Closeout Report

*Department of Energy
Review Committee*

RUN II LUMINOSITY PLAN at the FERMILAB TEVATRON

July 23, 2003

Luminosity Projections

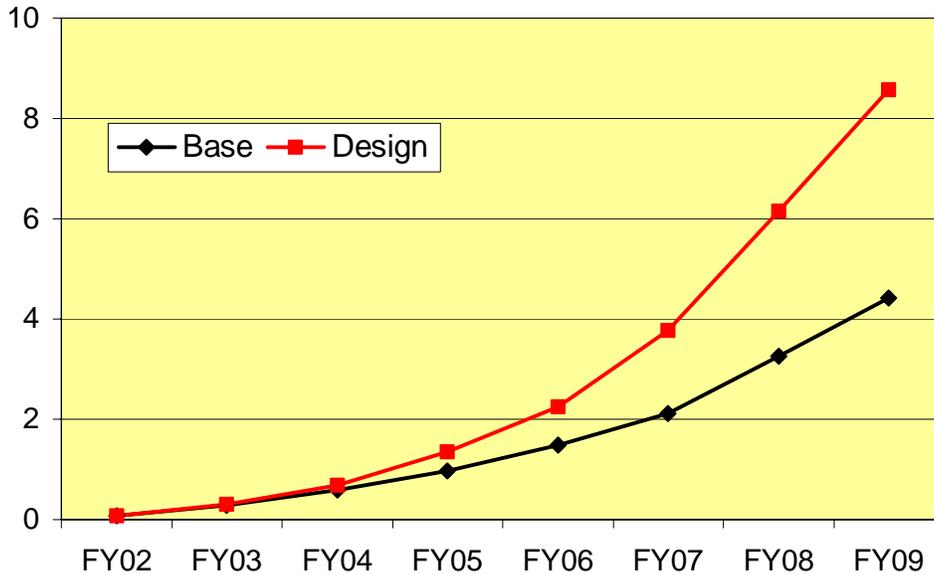
The Laboratory has presented two projections of the luminosity through FY09, a “design projection” of 8.6 fb⁻¹ and a “base projection” of 4.4 fb⁻¹.

Both projections assume successful integration of the electron cooling in the recycler. This represents a very significant uncertainty.

The committee views a projection of ~4 fb⁻¹ by the end of FY09 as having a reasonable probability of being met

Meeting the design projection of 8.6 fb⁻¹ by the end of FY09 is very challenging
